DG-GOLIATH	Qty:-1	Client :- M/s. ISGEC HEAVY ENGINEERING LTD.	Job Reference No. :- 132
Designed by DEEPAK	Checked by AMIT	Approved by - date R_ARVA-01/01/2015	Filename DES-1327
G.A. DRAWING FOR 5.0 T DG-GOLIATH CRAI		Date 01/01/2015	Sca NTS
DWGNO.-GEPL/1327/01		Edition 00	She 1/2

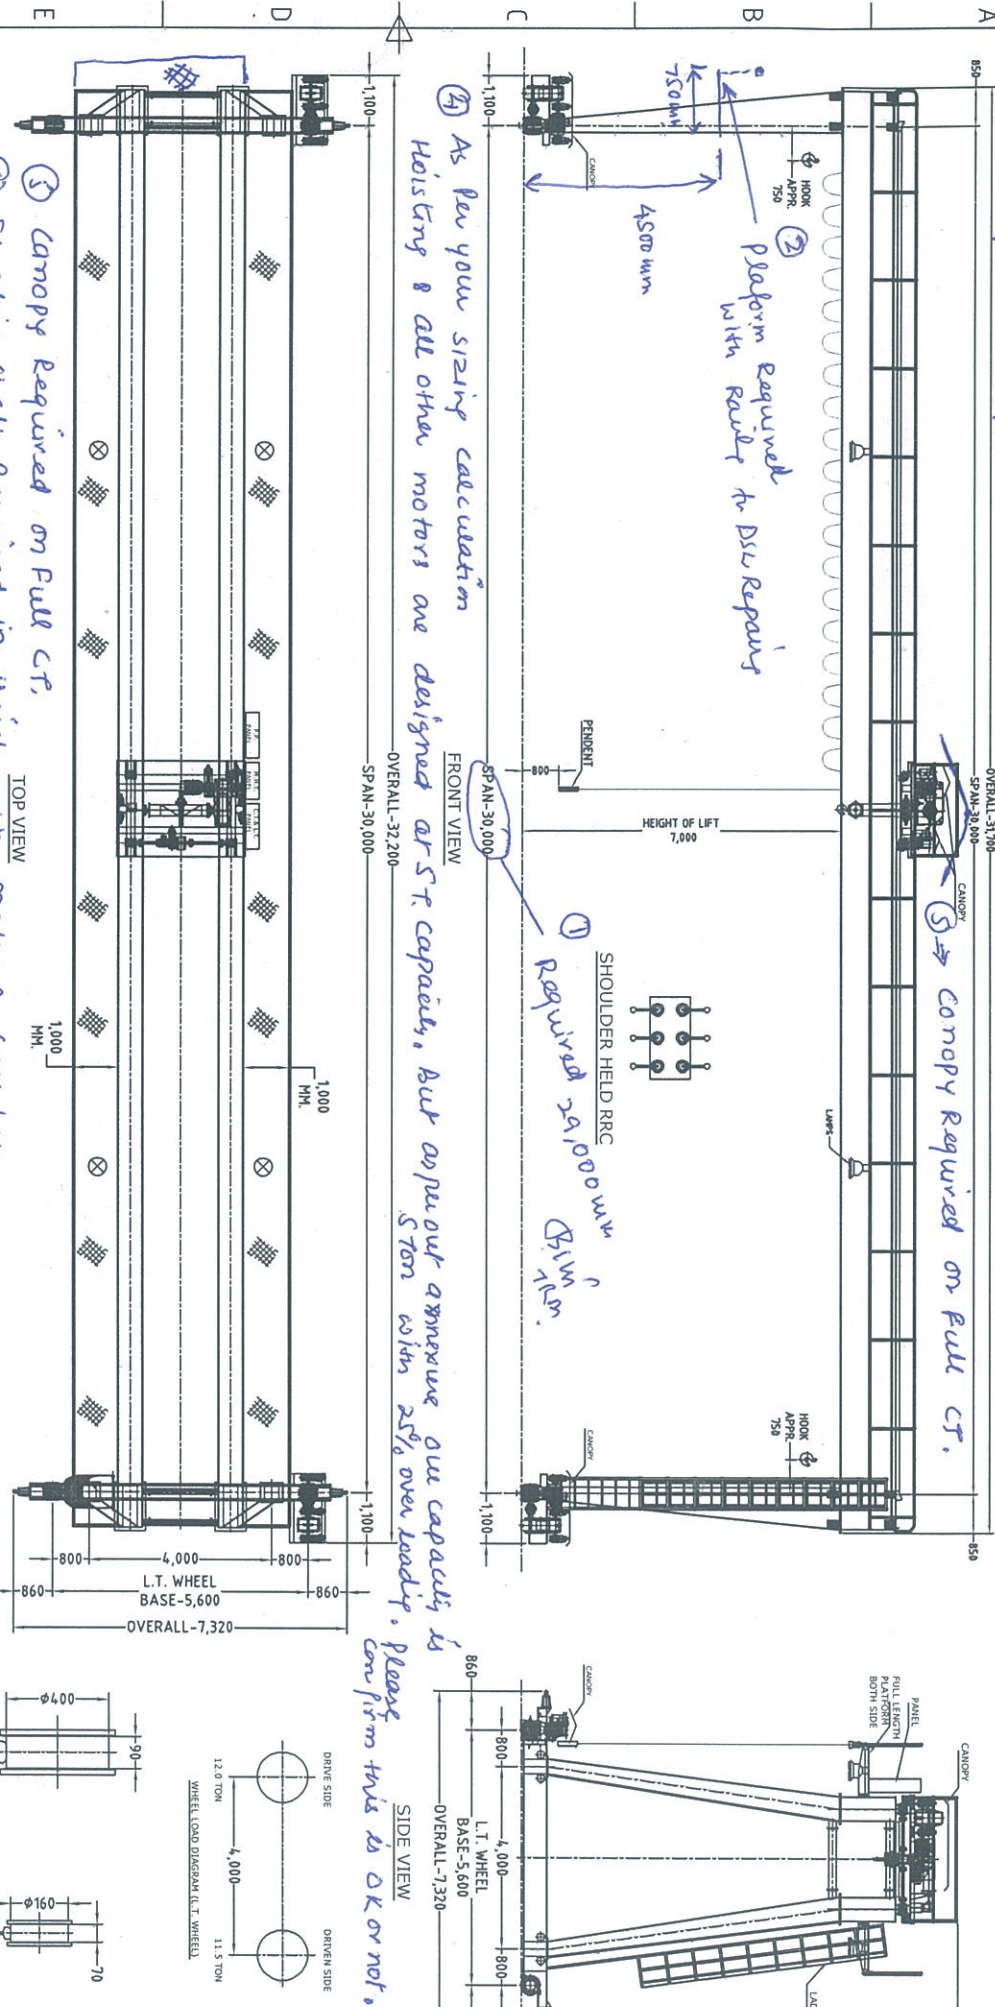
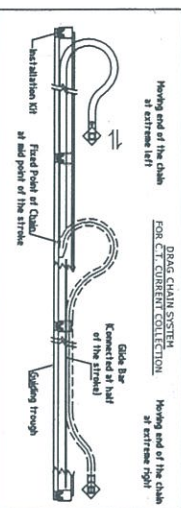
- ① Crane span is required 29mtr.
- ② Platform is required for Repair of DSL as per shown in Drawing.
- ③ Platform is required bt. main girders to cross from one girder to another.
- ④ As per your sizing calculation Hoisting & all other motors are designed at 5T capacity. But approval approve our capacity is 5Tm with 25% over load. Please confirm this is OK or not.
- ⑤ Canopy Required on Full CT.
